PLANNING AND ZONING COMMISSION
NOTICE OF VIRTUAL MEETING

Live Web Link: <http://laredotx.swagit.com/live>
PUBLIC ACCESS CHANNEL: Spectrum TV Channel 1300
Laredo, Texas
February 4, 2021
6:00 p.m.

MEETING AGENDA

Needmore Ranch Industrial Park Master Plan

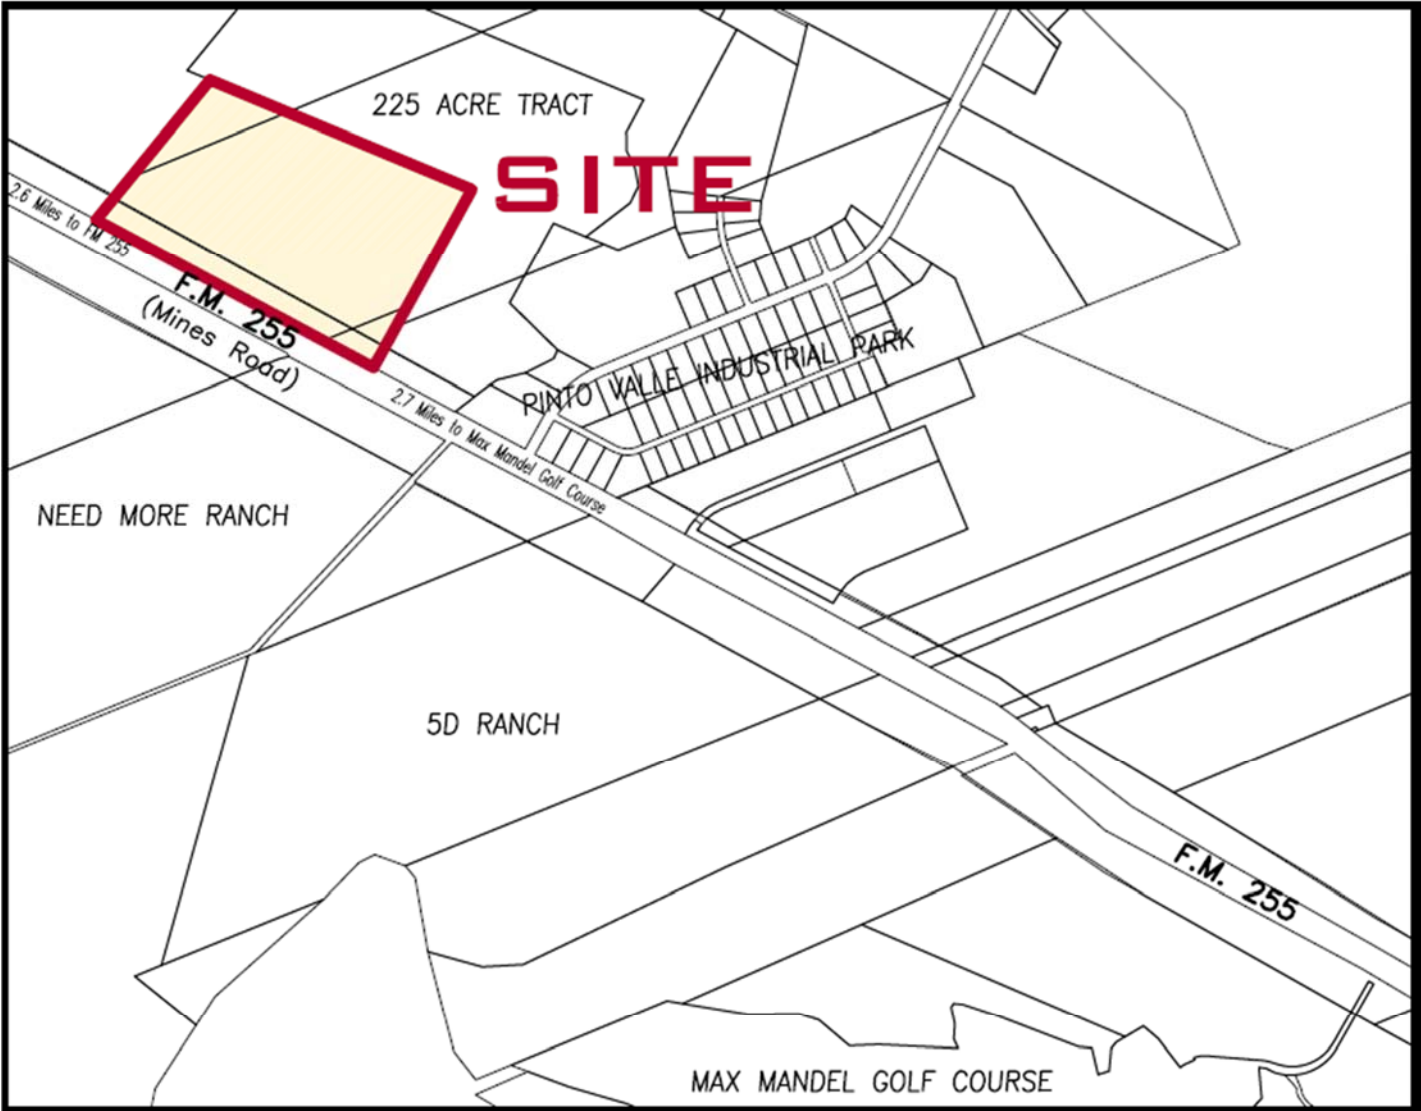
1. The entrances as depicted on the master plan must be approved by the Texas Department of Transportation prior to submitting an initial phase for preliminary consideration. Should changes to the entrances be mandated by TX-DOT resubmit master plan for review and reconsideration.
2. A zone change will be required for the intended use.
3. Provide correct name of highway (FM 1472 and not FM 255).
4. Provide plat note with X, Y coordinates for point of beginning and point of commencement.
5. Add a suffix to the street name of "Aggie Central".
6. Submit master plan revision to the City of Laredo Building Department GIS division within 10 days of commission approval in a geo-referenced CAD file in accordance with Section 2-3.2(a) 4 of the Laredo Subdivision Ordinance.
7. Identify all easements.
8. All improvements as per subdivision ordinance.

1. Sanitary and water feasibility study need to be provided for all the annexation area from the civil engineering of record to verify capacities of the system before preliminary approval.
2. Project subject to Pinto Valle Sanitary sewer agreement fees.
3. Plan needs to show projected flows and demands, require seal of the Engineer of record.
4. Indicate propose water and sanitary sewer connections and water and sewer mains being considered. Provided projected flows and demand for lots.
5. Subject to further comment based on utility layout submittal.

1. A Traffic Impact Analysis (TIA) will be required due to the size of the development, developer should contact TxDOT to coordinate TIA requirements.
2. The developer will need to meet with TxDOT to discuss the location of the proposed access, this needs to happen before the plat gets approved.
3. Another developer that is neighboring this development approached to TxDOT back in December 2020, It will be beneficial to coordinate a meeting in between both developers, City of Laredo and TxDOT in order to coordinate access, internal flow and thoroughfare plan.

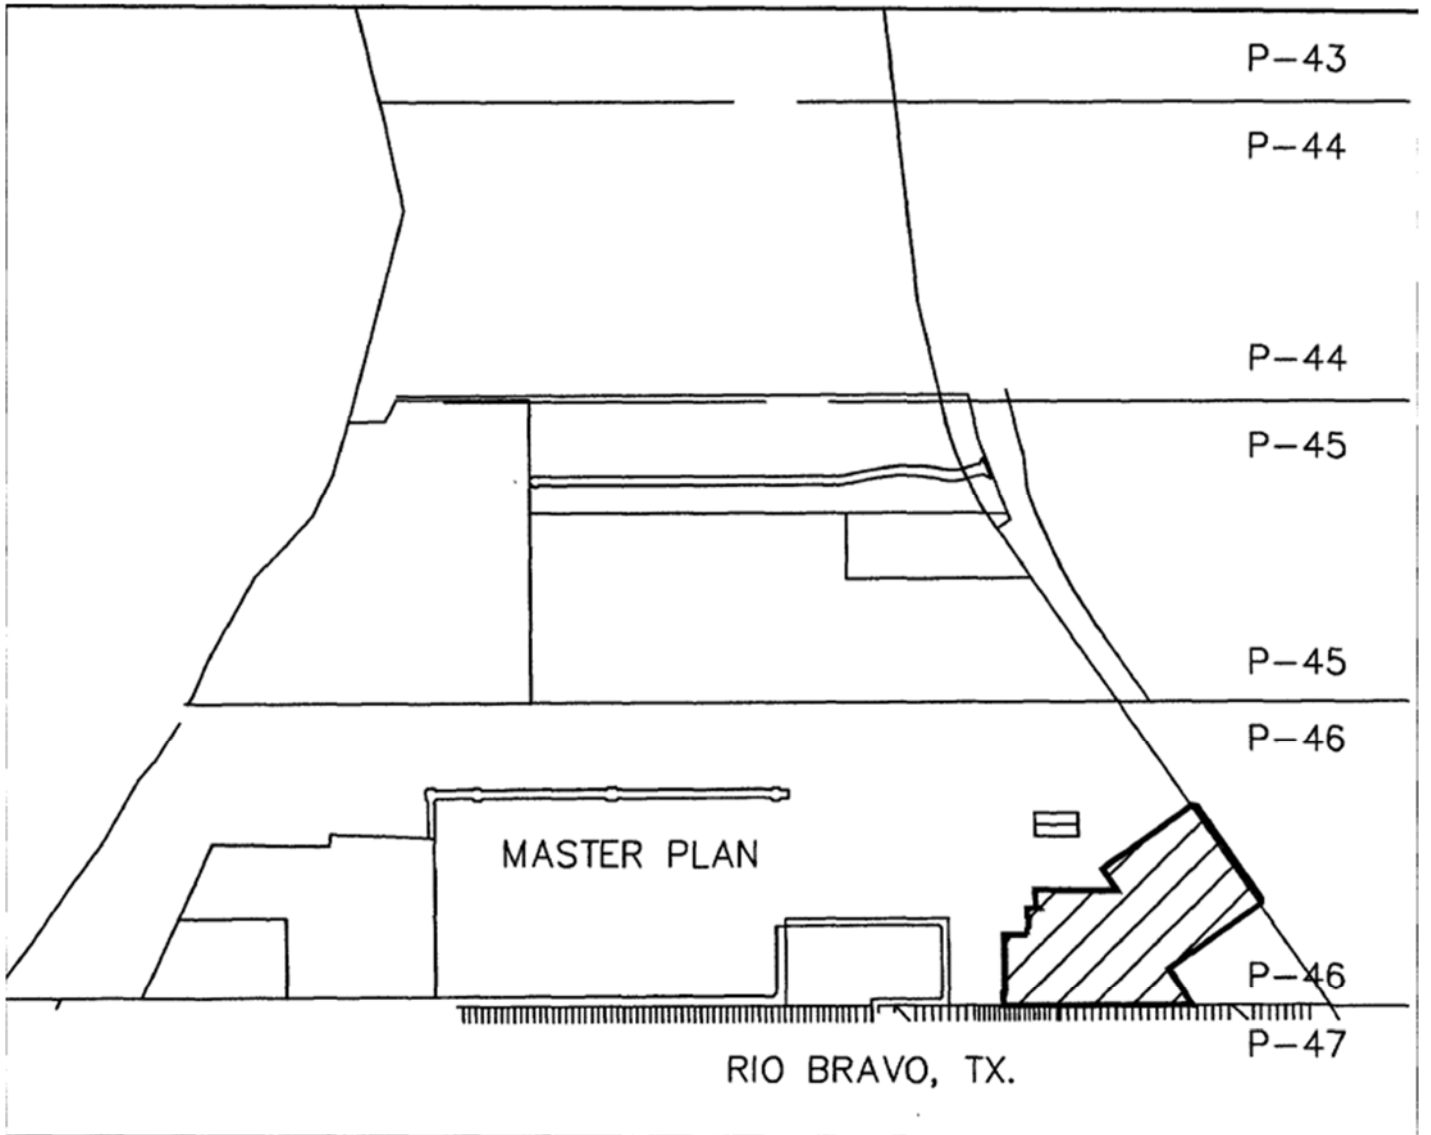
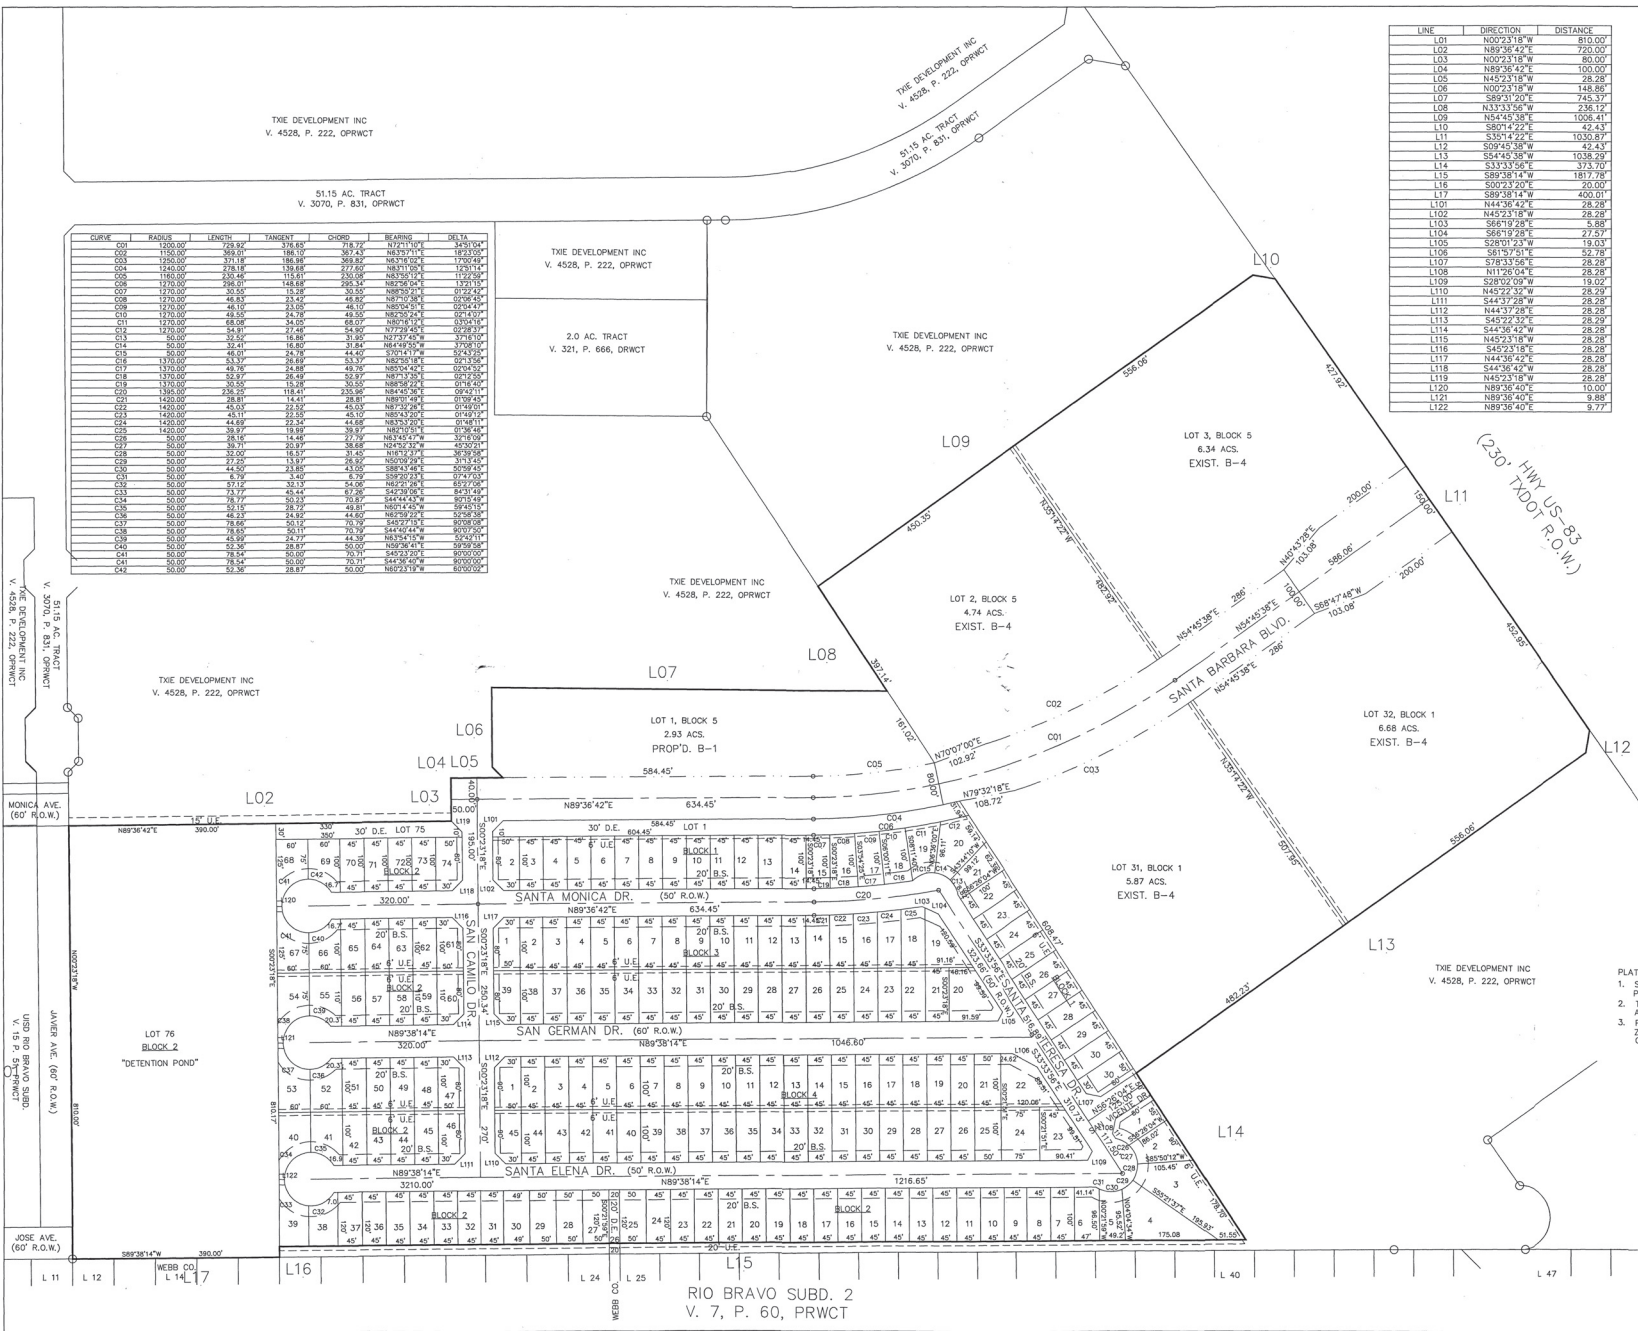
1. Provide alternate names for the following streets which are already in use:
 - Santa Barbara
 - Santa Monica
2. A zone change will be required for Lot 1, Block 5, which proposes a B-1 use.
3. The area proposed as residential is currently zoned R-1. A zone change will be required to R-1A based on the proposed lot sizes.
4. Secure approval from TX-DOT for the proposed Santa Barbara Boulevard.
5. Provide plat note with X, Y coordinates for point of beginning and point of

6. Provide additional detail on Vicinity Map.
7. Provide scale for Vicinity Map which should be drawn at a scale of 1" = 2000'
8. Coordinate the driveway placement for Lot 19, Block 4, with the Traffic Department and make adjustments as necessary.

9. Provide approval from the Webb County Water Utilities Department as this subdivision is located within Webb County's Certificate of Convenience and Necessity for the provision of water and wastewater services.

10. Provide evidence of compliance with the Model Rules including copies of executed water and wastewater agreements by the County of Webb.
11. Modify dates shown on City Engineer Approval Certificate to reflect correct date of plat.

1. Provide all necessary easements.
2. Address storm water detention.
3. Label Lot 76, Block 2 as drainage easement.
4. Clarify if San Vicente Dr. will extend on the back of Lots 31 and 32, Block 1.
5. Provide the revised Master Plan.

1. No Jurisdiction on the Rio Bravo water and sewer system, an inter-local agreement need to be motivated by the owner or landlord to clarify who will be responsible for the maintenance of the water and sewer improvements.
2. Extension of the main lines to the actual city of Laredo system will be required by the owner.
3. Utilities Department is not approving this preliminary until clarification are made.
4. Subject to further comment based on utility layout submittal.

1. Connection to US 83 will have to be worked out with TX-DOT.
2. What is the full extent of the property? Is there a Master Plan? It appears Santa Barbara Blvd will continue in the future.
3. The access to the frontage lots should be worked concurrently with this submittal.
4. Streets shall intersect perpendicular for a min of 100 feet.
5. L-Shaped type intersections shall not be less than 72 degrees and not greater than

6. Check sight distance at San German and Santa Teresa.
7. Remove San Vicente Dr. It is too close to the other streets. That road does not comply with the ordinance.
